Project	IEEE 802.16 Broadband Wireless Access Working Group < <a href="http://ieee802.org/16">http://ieee802.org/16</a> >	
Title	Improved CTC Performance	
Date Submitted	2005-01-13	
Source(s)	T. Keith Blankenship Yufei Blankenship Brian Classon Motorola	keith.blankenship@motorola.com yufei.blankenship@motorola.com brian.classon@motorola.com
Re:	IEEE 802.16maint-04/10 (12-21-04)	
Abstract	This contribution demonstrates that the convolutional turbo code (CTC) interleavers for block sizes 120 bytes and above have performance deficiencies. By selecting different interleaver parameters for these block sizes, the deficiencies can be corrected. The performance improvement in AWGN at $10^{-4}$ FER with the new parameters is at least 0.5 dB and in some cases up to 1.3 dB.	
Purpose	To provide improved CTC channel coding interleaver parameters when supporting H-ARQ.	
Notice	This document has been prepared to assist IEEE 802.16. It is offered as a basis for discussion and is not binding on the contributing individual(s) or organization(s). The material in this document is subject to change in form and content after further study. The contributor(s) reserve(s) the right to add, amend or withdra

Figure 1. FER performance for currently specified CTC interleavers.

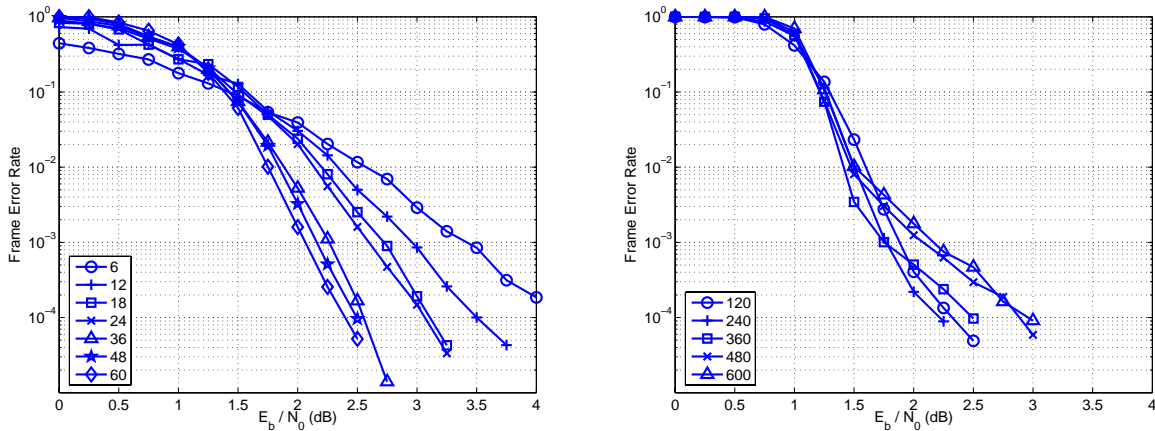
The performance of the  $6n$ -byte block sizes displays the expected turbo code behavior of improving performance with increasing block size. Furthermore, no error floor is discernable down to a FER of  $10^{-4}$ . However, the performance of the  $120n$ -byte block sizes displays the opposite. Here, the performance degrades with increasing block size (above 240-byte) and a distinct error floor is present.

Figure 2. Performance with new CTC interleaver parameters.

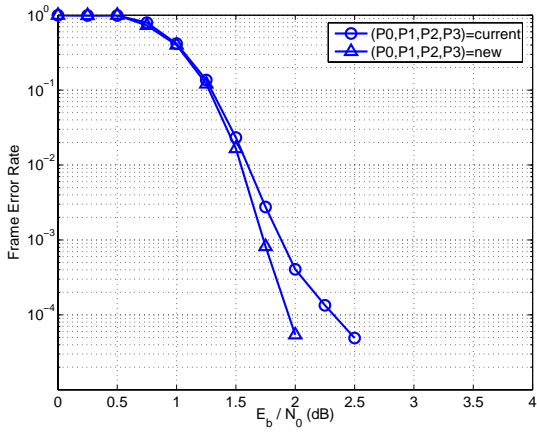
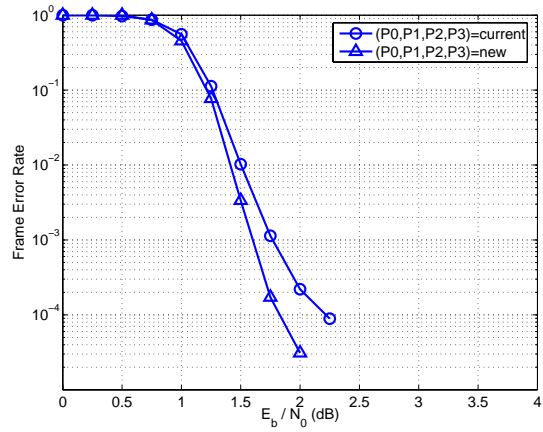
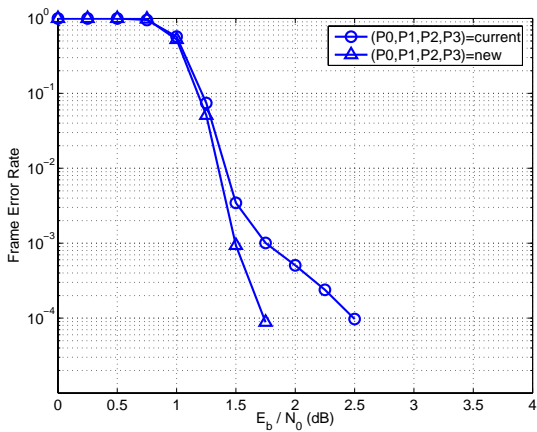
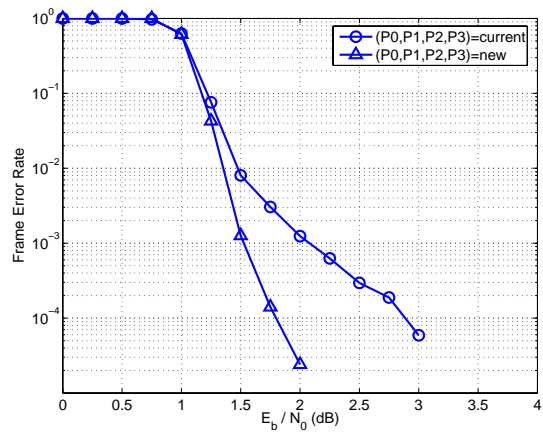
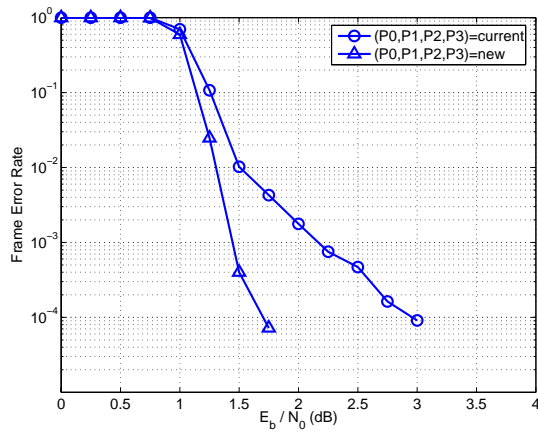
A new set of CTC interleaver parameters was designed to correct the performance deficiencies of the  $120n$ -byte block sizes. The new parameters were selected according to guidelines prescribed in [1]. The FER performance (rate-1/2, binary modulation, static AWGN channel, 7.5 decoding iterations, and “genie” circulation state knowledge) with the new parameters is plotted in Figure 2. The figure shows that the new parameters correct the performance deficiencies of the current parameters. At  $\text{FER} = 10^{-4}$  the performance with the new parameters is at least 0.5 dB and in some cases up to 1.3 dB better than with the current parameters.

<Add the revised Table 327 to new section 8.4.9.2.3.1 on p. 79. Table 327 appears on p. 598 on 802.16-2004.>

Table 327 – Optimal CTC channel coding per modulation when supporting H-ARQ

Data block size (bytes)	N	P0	P1	P2	P3
6	24	5	0	0	0
12	48	13	24	0	24
18	72	11	6	0	6
24	96	7	48	24	72
36	144	17	74	72	2
48	192	11	96	48	144
60	240	13	120	160	180
120	480	13 53	240 62	120 12	360 2
240	960	13 43	480 64	240 300	720 824
360	1440	17 43	720	360	540
480	1920	17 31	960 8	480 24	1440 16
600	2400	17 53	1200 66	600 24	1800 2
